***Drawings***

**Remarks****Specification**

**Claim Rejections – 35 U.S.C. § 102**

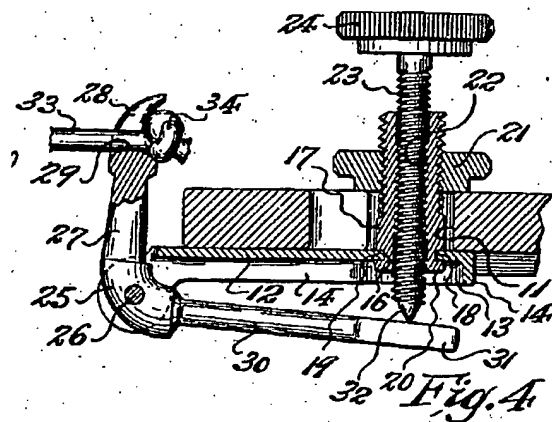
Proll teaches a musical instrument (see next page) with a string 33 attached to a forked first end 28 of a L-shaped lever 30. First end 28 is **above** a top surface of the instrument

body (not numbered) so that it interferes with the user's fingers during play. Further, the proximity of end 28 to a played portion of string 33 may result in premature string breakage where string 33 meets first end 28.
